Response to Comments

REVISIONS to the KERN COUNTY ZONING ORDINANCE – 2020 (A)
Focused on Oil and Gas Local Permitting

Kern County
Planning and Natural Resources Department
Bakersfield, California

Re: Chapter 7 - Response to Comments for Draft Supplemental Recirculated Environmental Impact Report (2020/2021) – for Revisions to the Kern County Zoning Ordinance – (2020 A), focused on Oil and Gas Local Permitting

Figure 1 – Distribution of directional, horizontal and vertical wells drilled in Kern County since 2009.² Black dots are vertical wells, gold dots are horizontal wells, and red dots are directional wells. (Scale bar at lower right.)

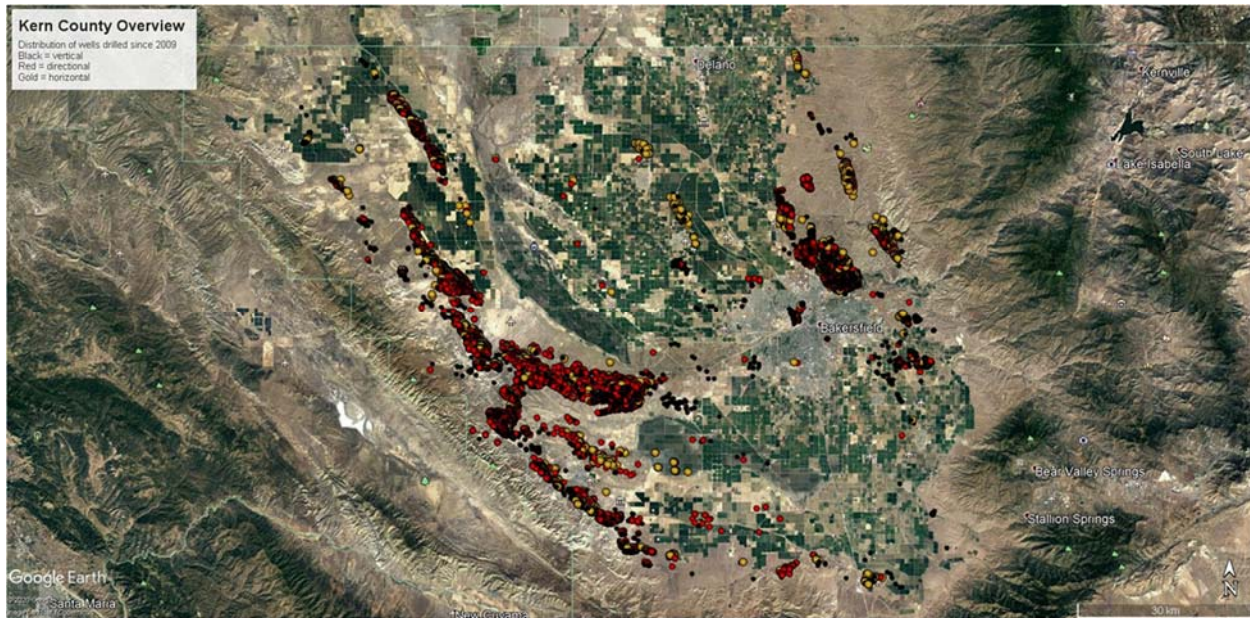
Response: Directional and horizontal drilling have become the norm in Kern County over the past decade. Figure 1 illustrates the distribution of directional, horizontal and vertical wells drilled in Kern County since 2009.

Figure 2 – Drill type by year of first production in Kern County, 2000 through 2020.³

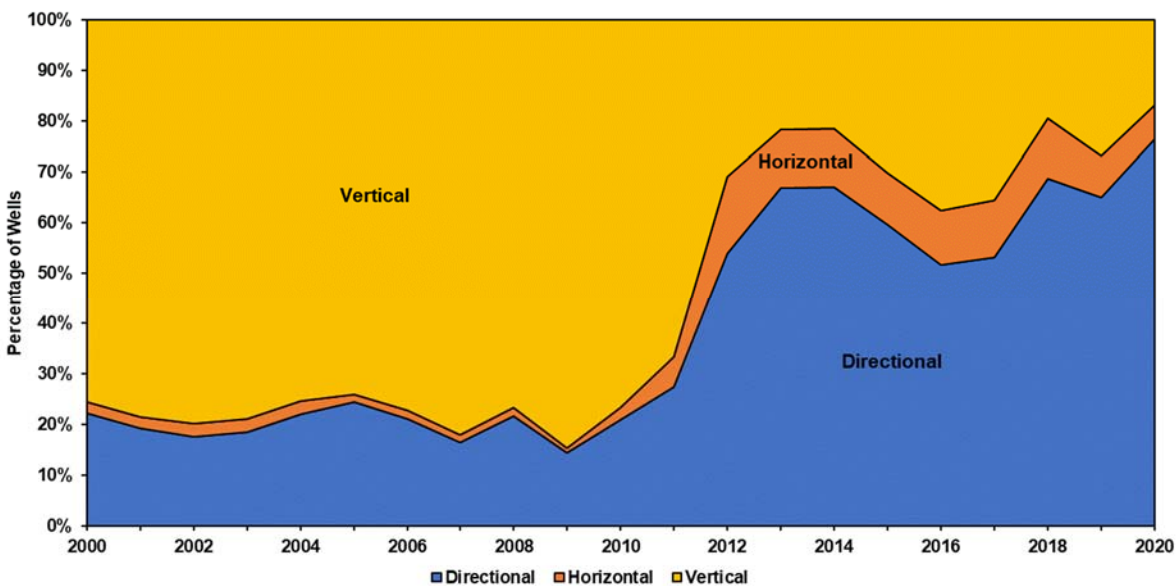
Figure 2 illustrates drilling by well type from 2000 to 2020. Whereas 76% of all wells drilled in 2000 were vertical, in 2020, directional drilling accounted for 76% of wells, horizontal drilling accounted for 7%, and vertical wells accounted for just 17%.

Figure 4 – Examples of multi-well pads in the Wasco area of Kern County showing wells drilled since 2009. Black dots are vertical wells, gold dots are horizontal wells, and red dots are directional wells. (Scale bar at lower right.)

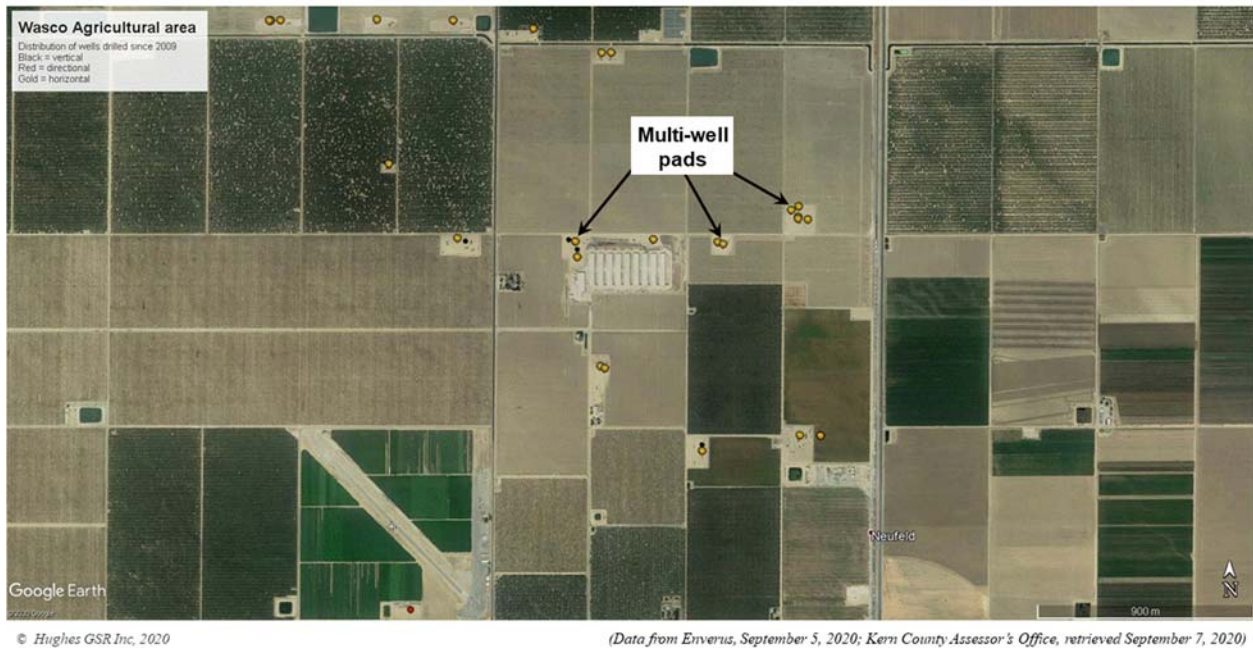
Multi-well pad drilling is feasible, and has already been implemented in some parts of Kern County. Figure 4 illustrates several well pads, each with two or more wells, on agricultural land in the Wasco area. One pad has four horizontal wells, another has two horizontal and two vertical

wells, and several others have two horizontal wells each. Clustered well regulations for any future development could mandate more wells per pad with pads spaced farther apart to minimize agricultural land disturbance.

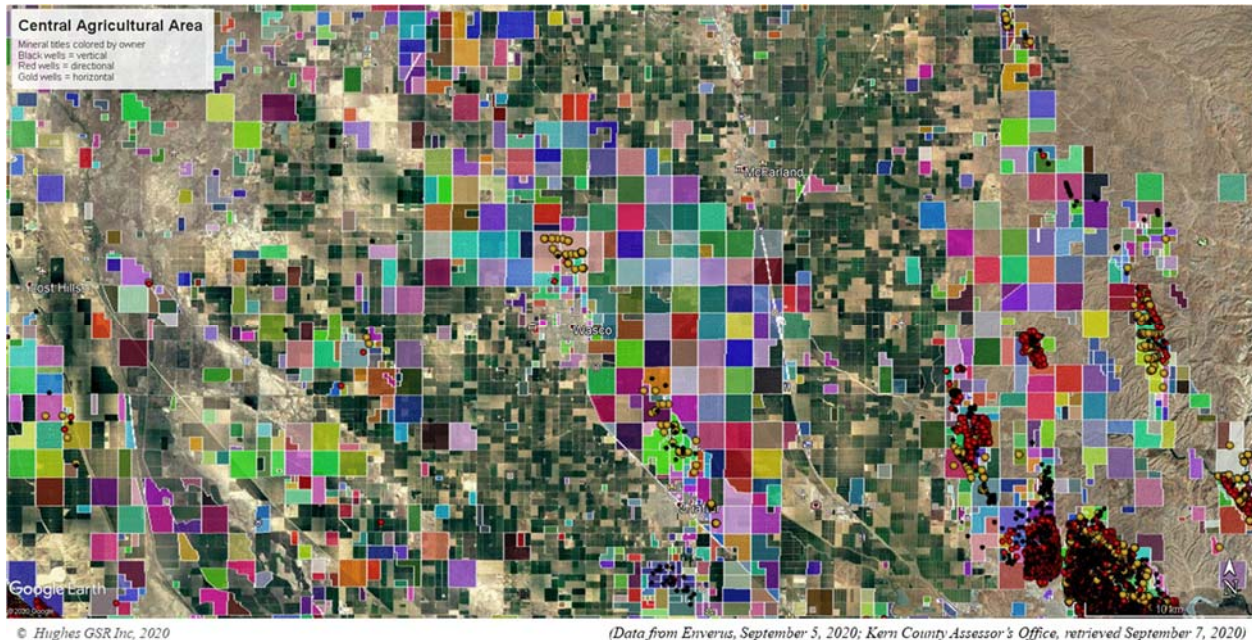
Response: Mineral tenure data are available from the Kern County Assessor's Office.⁴ They reveal that most individual mineral tenures are quite large; many are 640 acres in area, so, in most cases, clustering should not result in the access problem claimed by the SREIR. Figure 5 illustrates mineral tenure in the central agricultural area of Kern County, along with the distribution of horizontal, directional and vertical wells drilled since 2009.

Figure 6 – Distribution of mineral tenure in agricultural area north of Shafter (colors indicate individual ownership). Also shown are wells drilled since 2009 (black = vertical; red = directional; gold = horizontal).⁶ Horizontal wells have been used in much of the area. (Scale bar at lower right.)

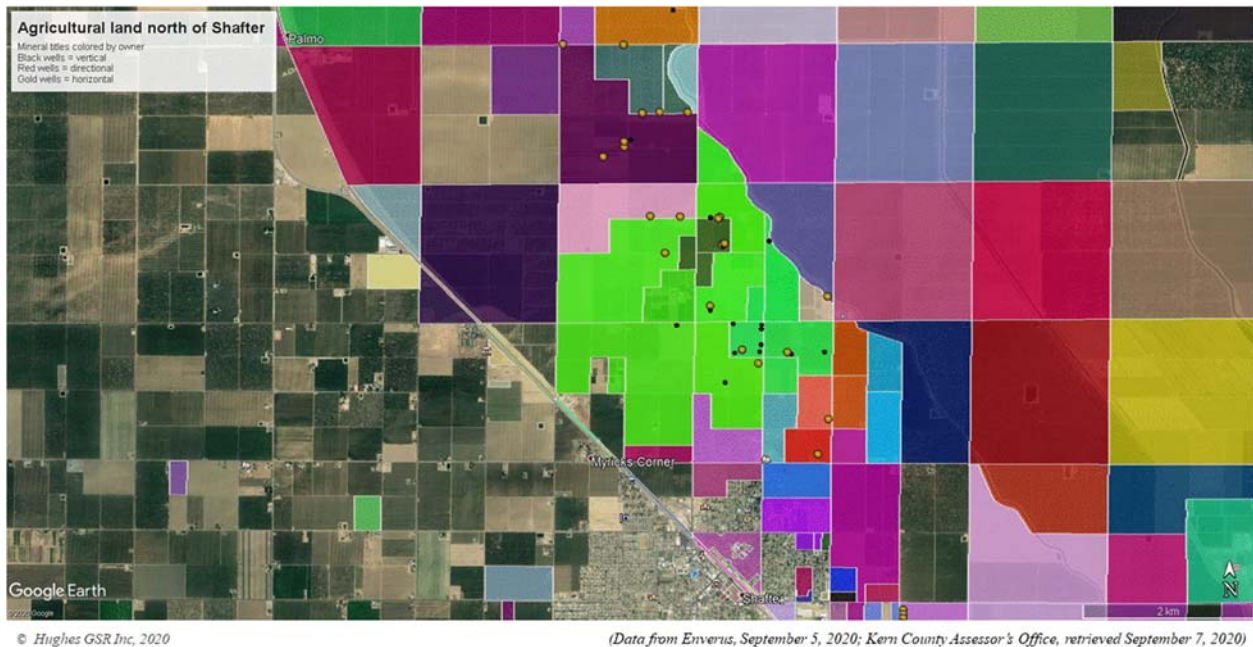
Figure 6 illustrates agricultural land in the Shafter Field north of the town of Shafter. Much of the development there is already from horizontal wells and the mineral tenure does not restrict further development with horizontal wells in most cases.

**Figure 1: Particle size distribution
 in Project PM₁₀ emissions of 659 tons/year**

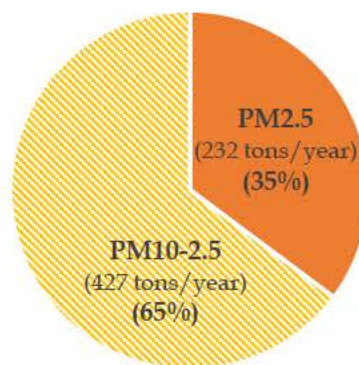
The Draft SREIR correctly calculates the percentage of PM_{2.5} of total estimated particulate matter emissions at 35% by dividing the PM₁₀ emissions (659 tons/year) by PM_{2.5} emissions (232 tons/year.) However, the following statement that “of total average annual incremental emissions of PM due to Project implementation... 65% of the emissions are PM₁₀ emissions” is nonsensical. As the Draft SREIR recognizes in its first calculation and elsewhere,²⁸ PM_{2.5} is a subset of PM₁₀ with the remainder being PM_{10-2.5}. Thus, 65% of the emissions of 659 tons/year (427 tons/year) are PM_{10-2.5}, as illustrated in Figure 1.

Figure 4: Annual emission reductions from 2013 through 2019 achieved through VERA-funded projects

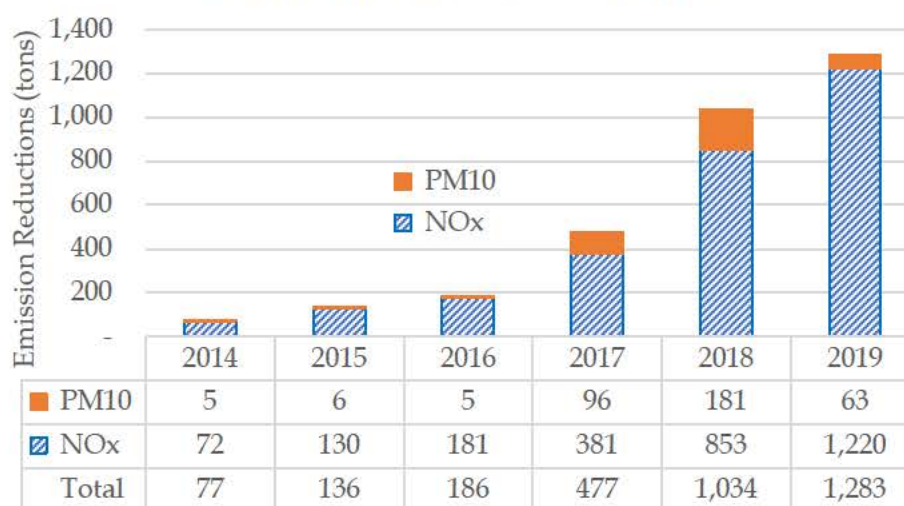
My review found that the majority of VERA-funded pollutant reductions target NOx, an ozone precursor, and provide only a small amount of PM10, and consequently PM2.5, emission reductions, as shown in Figure 4.

Figure 1. Location of Modeled Sources and Receptors

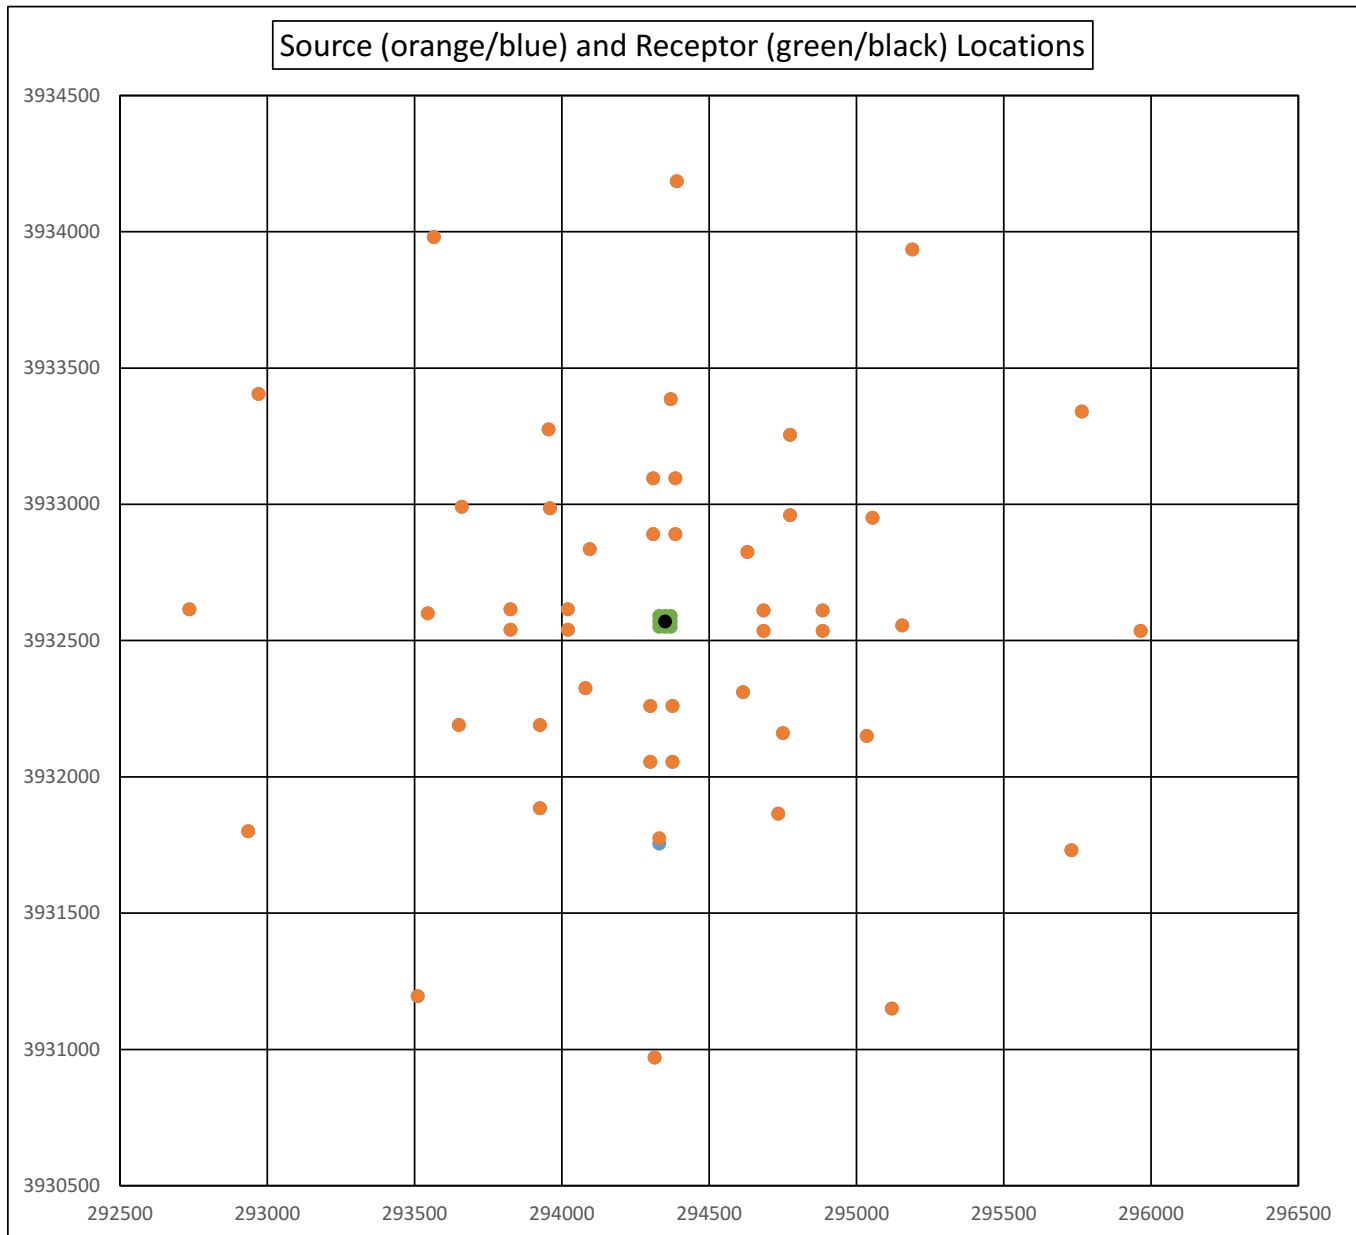
dark green and black (center point) in the figure. The wells in the two center circles are NOT evenly spaced around the circle, and the closest sources (wells) are located from 0.18 mi to 0.22 mi from the closest receptor (somewhat closer than 1/4 mi, but **NOT 1/8 mile**). The second ring of sources (wells) are located from 0.31 to 0.34 mi from the closest receptor (roughly 1/3 mile, **NOT 1/4 mile**). The third ring of sources are located between 0.48 and 0.49 mi from the closest receptors (slightly less than 1/2 mile, but **NOT 3/4 mile**). The outermost ring of receptors are 0.98 to 0.99 mi from the closest receptor (or 0.99 to 1.00 mi to the center receptor point). These actual distances clearly **DO NOT MATCH** the distances stated in the ECS report.

Figure 1 – Upper: surface ownership parcels north of Bakersfield. Lower: subsurface ownership for the same area. Large squares are 640 acres in area (data from Kern County assessor's office).

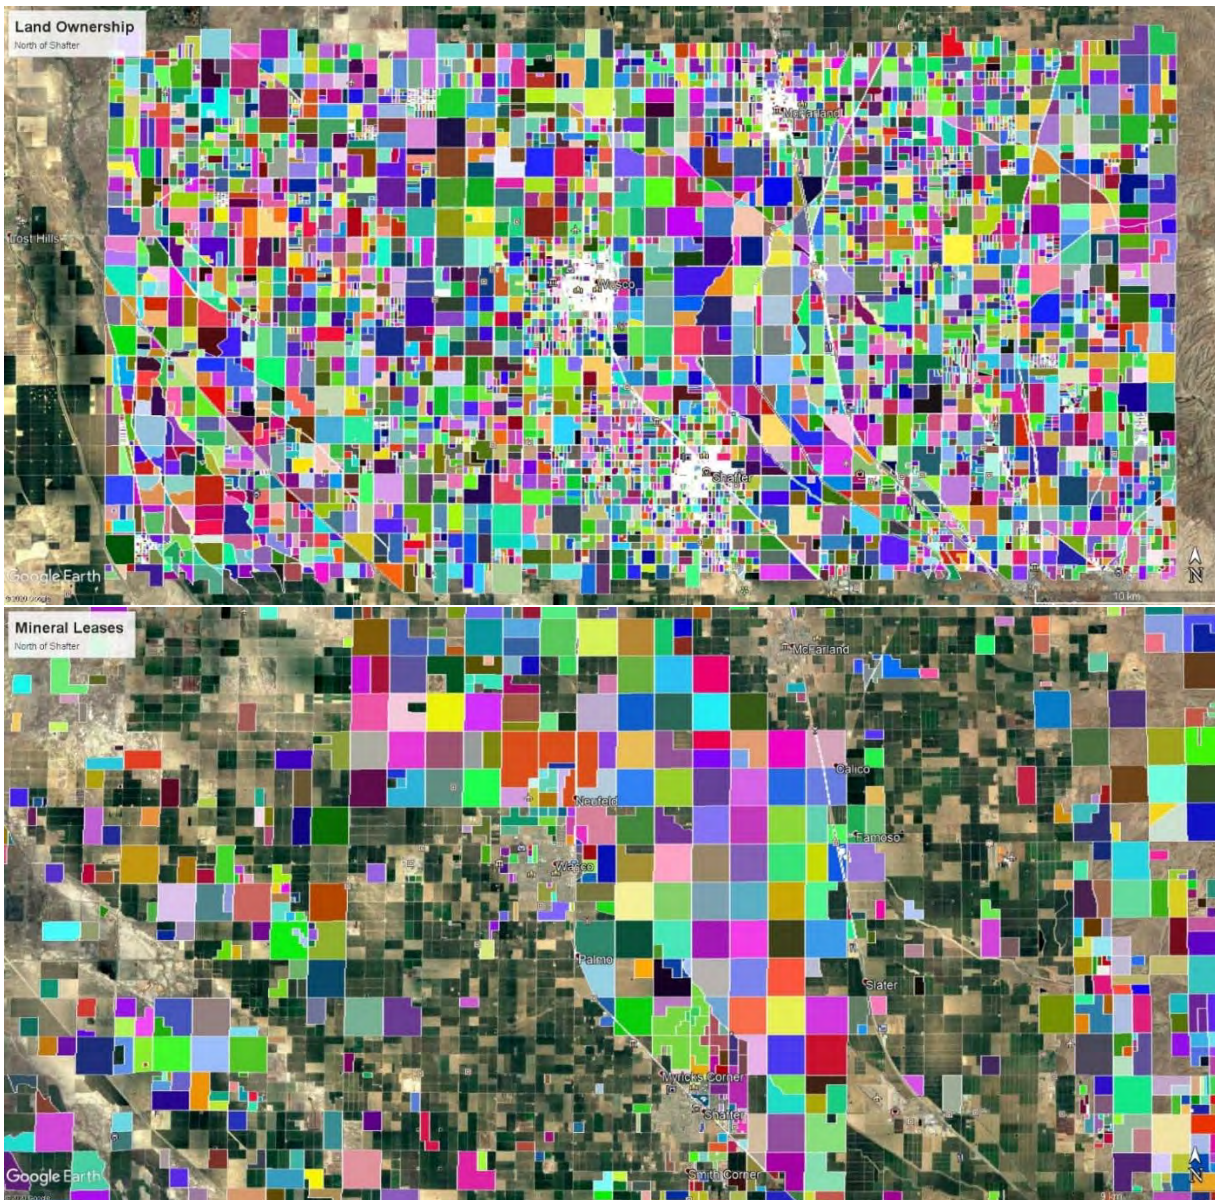
Response: In fact, subsurface leases tend to be much larger on average than surface parcels, so this would be a relatively rare occurrence. Figure 1 compares surface parcels to subsurface leases on agricultural land north of Bakersfield.

Plaintiffs have retained J. David Hughes, a Canadian earth scientist, to opine on Kern County oil and gas land title matters. Mr. Hughes claims that "subsurface leases tend to be much larger on average than surface parcels." Hughes December 10, 2020 Report at pp. 3 – 4. This statement is made to refute the SREIR claim on page 4.2-34 that single well-pads are needed because "one legal lot of agricultural land could have multiple distinct ownership subsurface leases." As the sole support for his statement, Mr. Hughes includes a figure, Figure 1., that purports to rely on Kern County Assessor data. Mr. Hughes is incorrect.

Data I obtained from California Resources Corporation shows that Mr. Hughes' Figure 1., while purportedly showing leases that are currently *assessed*, fails to include *all* leases in the area depicted in his Figure 1, as well as all mineral owners of those leases. (See Enclosure A.) Enclosure A contains information on *all* recorded, not only assessed, oil and gas leases in the area east of the City of Shafter, which is an area shown in Mr. Hughes' Figure 1. Not all recorded oil and gas leases are assessed, and not all mineral interests are assessed. Therefore, the data on which Mr. Hughes relies is incomplete. I am personally familiar with this area, and the oil and gas leases that are recorded within it, as I and my practice group have examined title and prepared numerous title opinions for California Resources Corporation in the area depicted on Figure 1.

Figure 2 – Total depth of Kern County directional wells drilled from 2010 to 2020 (data from Enverus retrieved September, 2020).

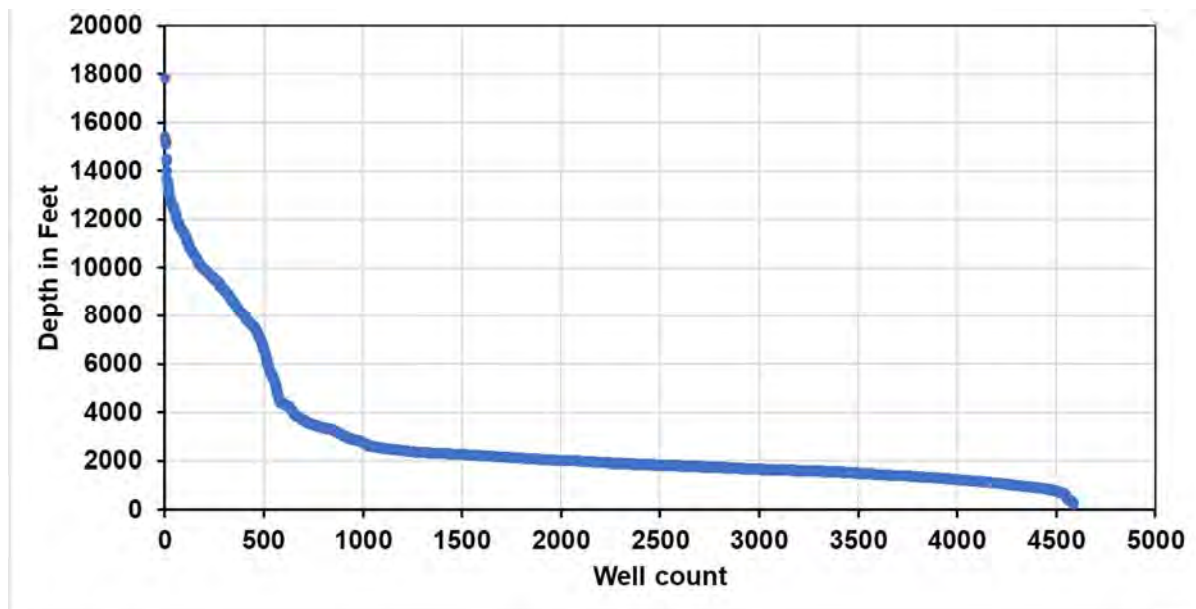
It is true that the deeper a directional well is, the more lateral offset can be achieved with a given inclination angle. Although many directional wells in Kern County are in the 2,000-foot depth range, some are greater than 16,000 feet. Figure 2 illustrates the distribution of directional wells drilled in Kern County by total depth from 2010 to 2020.

According to Figure 2 of this comment, it appears that approximately 90 percent of directional wells in Kern County are less than 5,000 feet deep, while wells less than 2,000 feet deep predominate. However, according to Table 1 of the comment, at a 20-degree angle of inclination, a well would have to be between 5,000 and 6,000 feet deep to achieve a 2,000-foot lateral offset, while a 2,000-foot well could achieve an offset of 684 feet. The theoretical offset distances in Table 1 do not accurately reflect real-world drilling design and so underestimate the drilling depths needed to reach a given lateral target, as explained in Velasco (2021), pp. 1–2. The lateral offset calculations in Table 1 incorrectly assume that wells will be drilled starting at an angle of 10 degrees, 20 degrees, 30 degrees, etc. However, this is not how directional drilling occurs. This does not account for the gradual curvature of the well bore (referred to as the “build rate”) that is necessary to achieve a given inclination from vertical, based on physical and equipment limitations. The total length of the well bore or measured depth, including its gradual curvature, will therefore be greater than the depth of a linear bore at a fixed angle. Table 1 also does not consider the initial vertical footage that must be drilled before beginning to deviate the curving bore from vertical.

Figure 2 of the comment illustrates that, though the majority of directional wells in Kern County are less than 2,000 feet deep, a substantial proportion of wells are deeper. Where deeper wells are drilled, they provide greater flexibility for designing drilling to reach desired targets. The geology must be amenable to drilling laterally, in addition to the wells being deep enough to accommodate gradual horizontal turns. However, the complex geological structures typical in Kern County are unfavorable for long distance horizontal drilling such as occurs in other parts of the United States, outside of California. Moreover, even where sufficient lateral offset to reach resources from clustered well pads is geologically and technologically feasible, a mitigation measure requiring well clustering raises other issues. See SREIR (October 2020), Vol. 1, at 4.2-33–40 and Responses to Comments 0059-38 and 0059-40 through 0059-43.
